Computer System Architects
 950 N. University Avenue
 Provo, Utah 84604
 (801) 374-2300
 FAX: 374-2306

Transputer Education Kit User Guide Errata

15 Oct 1990

Page 29

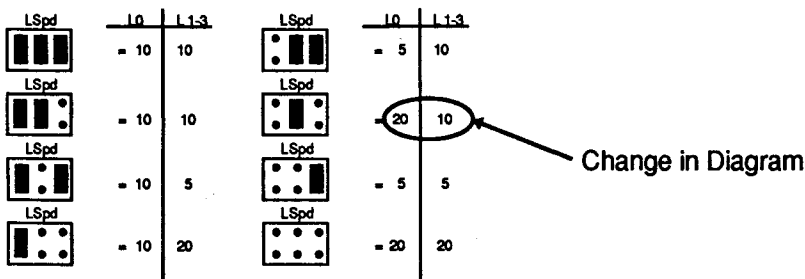
The following graphic in section 3.4.2 is in error. With one jumper installed, the user can select 20 Mbits/s for Link0 and 10 Mbits/s for Links 1,2 &3.

This is the corrected image:
